MEMORANDUM

SUBJECT: **Staff response to Planning Commission topics, the applicant's response and additional public testimony received for South Cooper Mountain High School (Case Files CU2015-0003, DR2015-0029, LD2015-0004 and ADJ2015-0005). Continued public hearing for June 24, 2015.**

Exhibit Showing Proposed Modification of Western Perimeter Landscape Plan

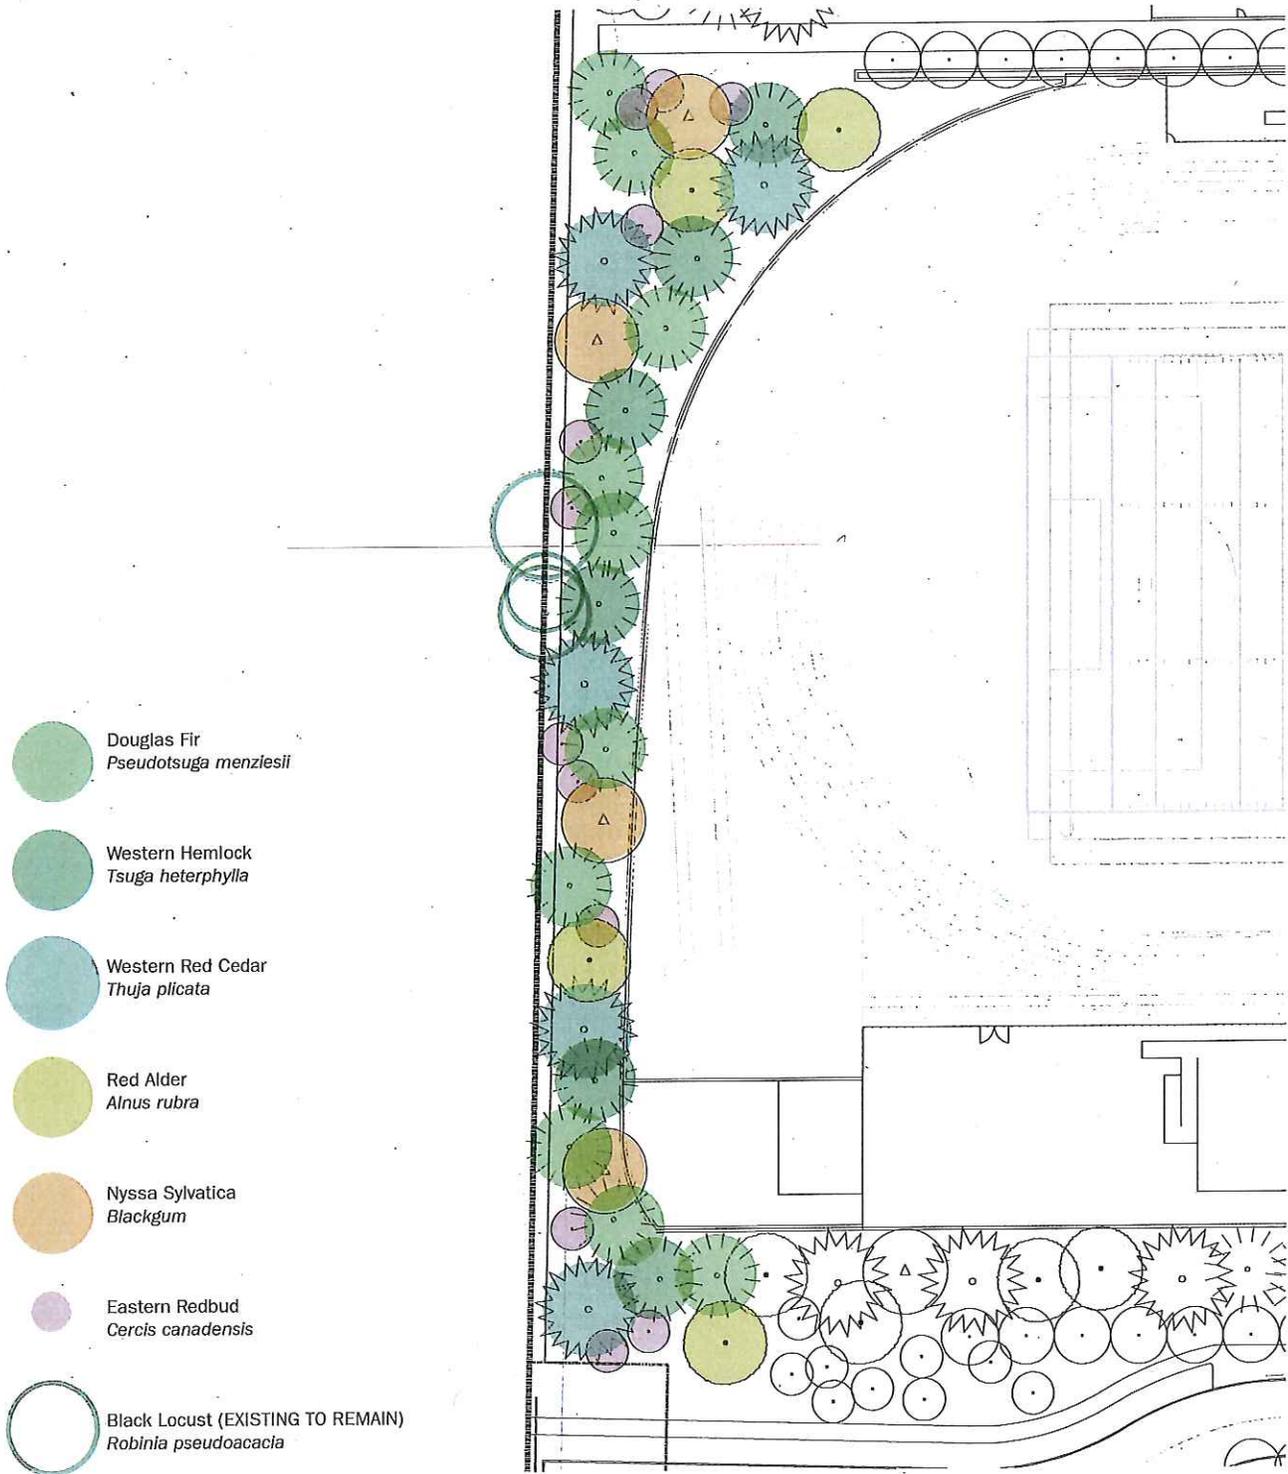
Staff notes that some of trees shown to this plan are deciduous. While a mix of deciduous and evergreen trees is generally acceptable for most landscape plans, deciduous trees provide limited visual screening during certain seasons of the year. Staff refers to the Conditional Use criteria where the impacts of the use are to be evaluated and mitigated as necessary. The District's tree simulation exhibit also shows only one angle / perspective from one existing dwelling. In part, Criterion No. 5 of Conditional Use approval refers to use and findings that support "...*minimal impact on livability and appropriate use and development of properties in the surrounding area of the subject site.*" Staff notes that the SCM-CP land use plan identifies High Density Residential to the Edmonds property. The same R-1 zoning that applies to the school property will likely apply to the Edmonds property. In that event, multi-family apartment/condominium buildings constructed near the school site could be four to five stories in height under the R-1 zone standard (60 feet).

To further screen the impact of stadium lighting on current and future residents of this area, staff proposes a condition of approval (of Conditional Use) that requires modification of the landscape plan. The modification proposal acknowledges the applicant's revised plan specific to that portion of the campus located along District/Edmonds property line where the stadium is proposed (see Attachment C hereto for landscape exhibit titled *Exhibit for Western Edge of Property*). The condition is proposed by staff for supportive findings in response to Criterion No. 5 of Conditional Use approval. The condition is also linked to Conditional Use approval so that it will run with the land, and recognize a purpose – being visual screening of stadium lights. Staff forwarded the plan revision to the City Arborist for comment. In review of the plan, the City Arborist notes that the Western Hemlock does not grow well and seldom survives the first year. The City Arborist also notes that the Eastern Red Bud is a small ornamental tree growing to only about 12 feet and that the Nyssa is a slow growing deciduous tree. The City Arborist recommends changing the Eastern Red Bud and Western Hemlock to Douglas fir and the Nyssa to Western Red Cedar. Staff has structured the proposed condition accordingly. If and when trees are removed in the future, the District would be required to replace accordingly.

- 11. Landscape for the school campus along western perimeter near the stadium is to be consistent with the tree planting plan titled "Exhibit for Western Edge of Property" and is to be modified to include the City Arborist recommended change where Eastern Red Bud and the Western Hemlock are changed in favor of Douglas fir and the Nyssa is changed to Western Red Cedar. To minimize the visual impact of illumination from stadium lighting, these trees are to remain as part of the approved landscape plan for posterity. If and when these trees are removed in the future, the District shall be required to replace in accordance the modified landscape plan.**
-
